From: Henson, Chris
Sent: Monday, October 31, 2016 12:39 PM
To: Allen, Michael (COB); Lenzi, Chelsea; sbcob
Cc: Farr, Doreen
Subject: FW: PCEC - Document Request Follow Up
Attachments: 9.15.09 pcec response to seep doc request.pdf; 10.17.09 seep documentation request letter.pdf; 6.15.11 seep letter.pdf; 7.27.11 seep occurrence.pdf; 9.3.09 seep documentation request letter.pdf; 9.4.13 Seep occurrence.pdf; 2011 seep letter occurrence.pdf

Re: Your letter of September 3, 2009; Re: Orcutt Field Seep Documentation

RE: Recommendation for Finding of Substantial Conformity (07SCD-00000-00049) for the BreitBurn Energy Company Orcutt Hill Diatomite Project Oil Drilling and Production Plan (05PPP-00000-00001).

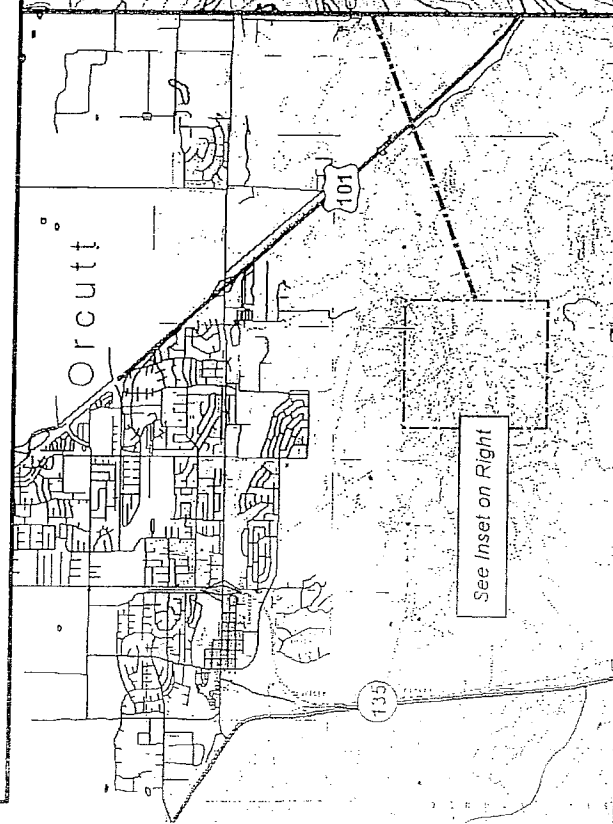
The development of oil well pod No. 2 at the revised location would require the relocation of one 28-inch oak tree to a site adjacent to the existing well pad (Figure 3). A proposed four-foot high cut slope on the eastern end of the western pad area at the relocated Pod No. 6 site (Figure 6) would encroach beneath the dripline of a 16-inch oak tree, and may impact more than 20 percent of the tree's critical root zone area. Disturbance of more than 20 percent is considered to result in a significant impact to the tree.

As indicated above, the relocation of a tree that may otherwise require removal, and construction operations that have the potential to impact a tree may be authorized with the approval of an acceptable tree protection plan. At minimum, the tree protection plan must implement the following measures to reduce impacts to native trees to a less than significant level: construction operations with the potential to impact a tree must be conducted in a manner consistent with the provisions of the tree protection plan; that impacted trees shall be replaced at a 10:1 ratio; and that financial assurances must be provided for the subsequent care of the relocated/impacted trees. Compliance with the previously adopted mitigation requirements would reduce impacts to native trees resulting from the proposed project revision to a less than significant level. Therefore, the proposed project would be consistent with approved conditions of approval and no previously unidentified impacts to native trees would result.

Proposed Pod 2 Location

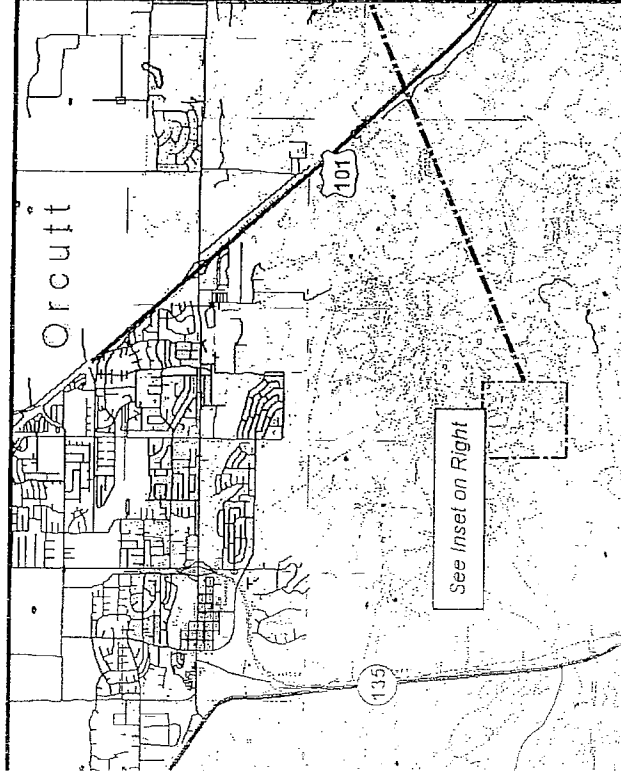
On 01/29/09, P&D received an application for a Substantial Conformity Determination to: 1) relocate wellpod 2, 2) construct a second tank battery near the existing Newlove tank battery, 3) construct a new wastewater treatment plant, 4) install new pipelines, and 5) extend wellpod 1. On 02/11/09, P&D received a letter from the applicant modifying their proposed project description. As a result, the applicant's proposal is just to extend wellpod 1.
